REGIONAL REVIEW FINDING

ARC REVIEW CODE: R1603291

Name of Proposal: Dunwoody Crown Towers

SUBJECT: **Transportation Division Review of DRI # 2567**

1 SITE PLAN - DRI
1" = 150'-0"

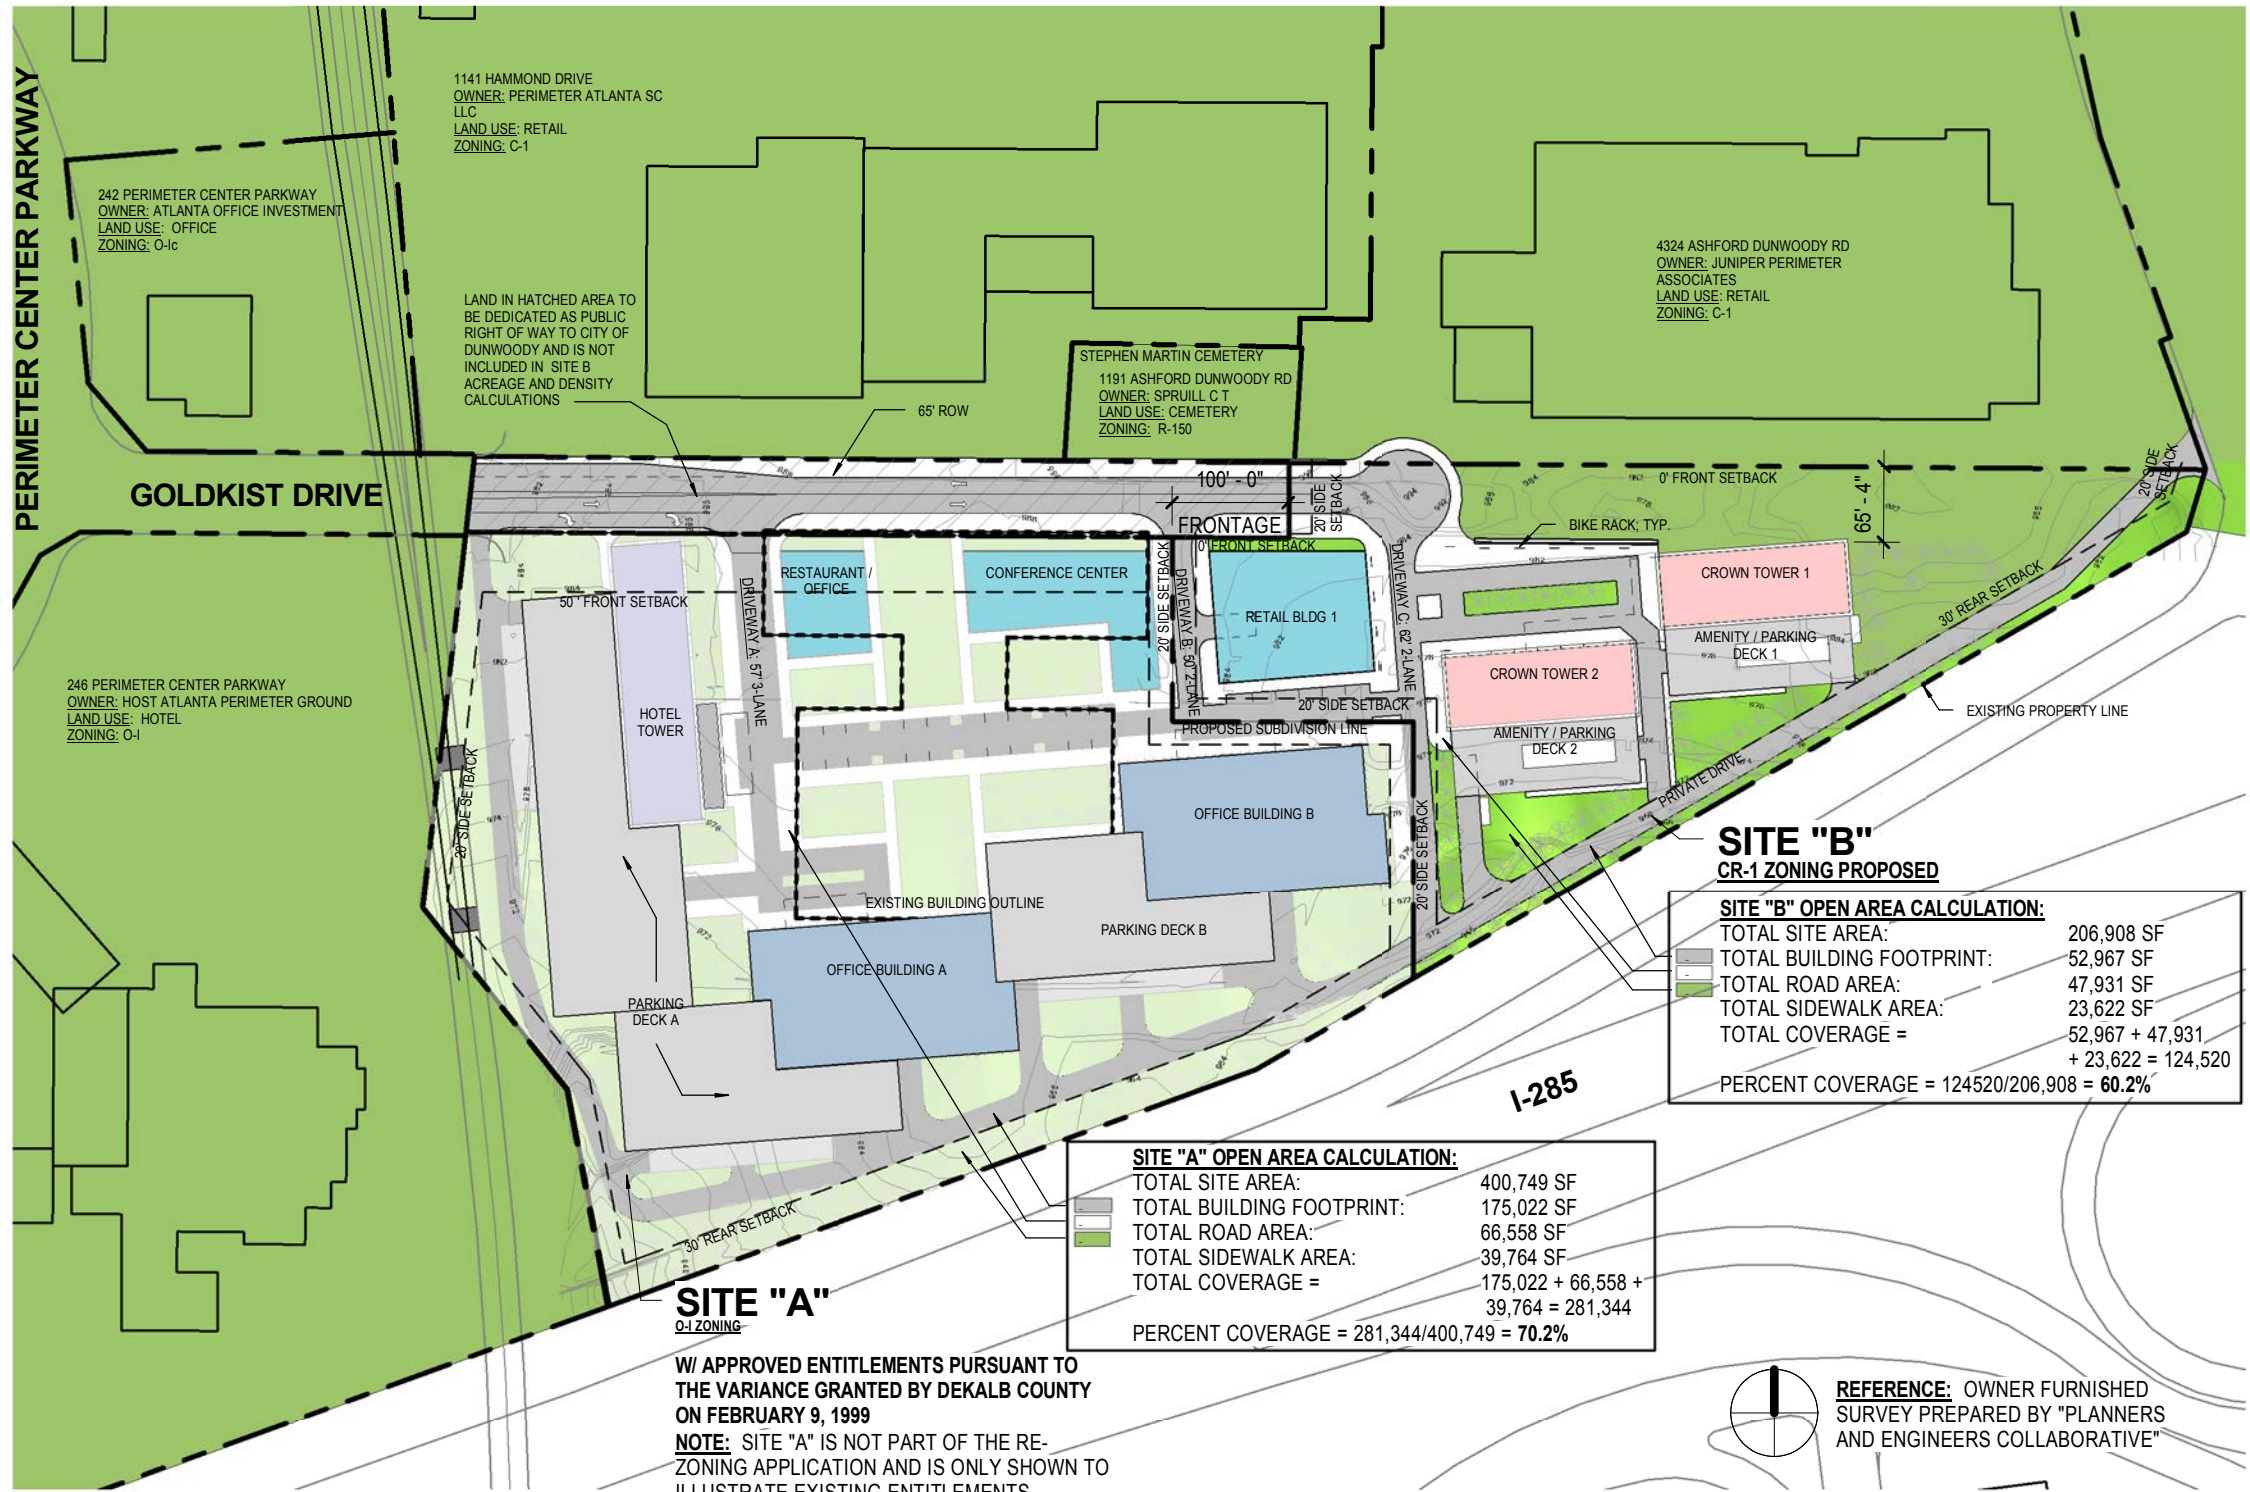
The site plan in the Preliminary Report shows an access to Ashford Dunwoody with very close proximity to the WB on ramp to I-285. There existing "dustpan" drive in this area exists due to ROW negotiations during the Ashford Dunwoody Diverging Diamond conversion. This was left in place as a maintenance only access the cemetery adjacent to the Goldkist site. I'm sure this will be a point of discussion as the process moves forward.

Off-street loading for site “B” is identified on the site plan, but loading spaces for the other buildings was not identified. Adequate off-street loading spaces should be provided for all proposed buildings and should meet the zoning and other relevant ordinances from the City of Dunwoody.
